State of New Mexico
 Energy, Minerals and Natural Resources

WELL API NO. 30-015-34222
5. Indicate Type of Lease STATE <input checked="" type="checkbox"/> FEE <input type="checkbox"/>
6. State Oil & Gas Lease No.
7. Lease Name or Unit Agreement Name Spud 16 State
8. Well Number 5
9. OGRID Number 6137
10. Pool name or Wildcat Laguna Salado; Atoka (gas)
11. Elevation (Show whether DR, RKB, RT, GR, etc.) 2962' KB

SUNDRY NOTICES AND REPORTS ON WELLS
 (DO NOT USE THIS FORM FOR PROPOSALS TO DRILL OR TO DEEPEN OR PLUG BACK TO A DIFFERENT RESERVOIR. USE "APPLICATION FOR PERMIT" (FORM C-101) FOR SUCH PROPOSALS.)

Well Name: SPUD 16 ST 5			Field: Potato Basin		
Location: 2320 FSL	660 FEL	SEC 16-T23S-R29E	County: Eddy	State: New Mexico	
Elevation: 2962' GL			Spud Date: 10/24/2005	Compl Date: 3/1/2006	
API#: 30-015-34222	Prepared by: Max Lubitz	Date: 9/27/18	Rev:

PROPOSED WELLBORE

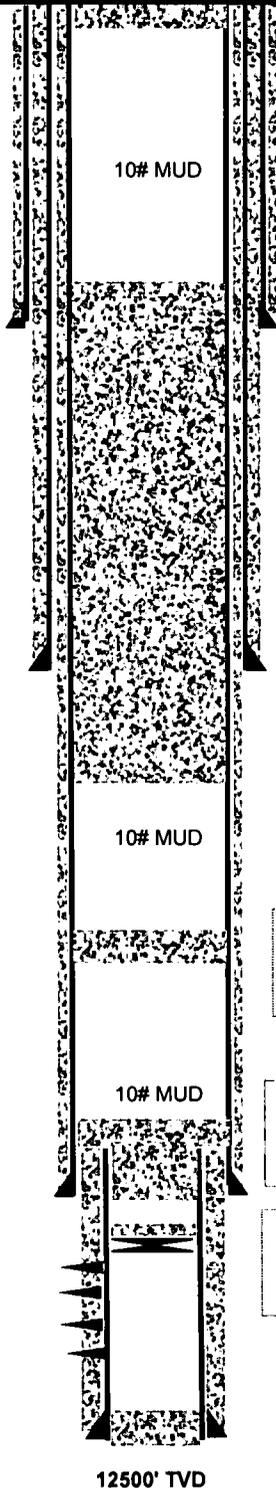
- MIRU P&A Unit.
- TOH 2-7/8" tubing.
- Circ 10# Mud. Set CIBP @ 12100'.
- Spot ~~20~~ 5x CI C cmt 12000'-12100'. - WOC + Tag
- Spot 50 sx CI C cmt 9900'-10500'. WOC & Tag. (Liner top 10142', T. Wolfcamp 10070)
- Spot 100 sx CI C 6500-7000. (T. Bone Spring 6687')
- Spot 700 sx CI C 292-3600. WOC and Tag. (Shoes 342, 2948, T Bell Canyon 3035', B Salt 2775, T Salt 378, R-111P)
- Spot ~~10~~ 5x CI C 3'-33'.
- Cut WH off 3' BGL, Set dry hole marker.

*** See Attached COA's must be plugged by 10-18-19**
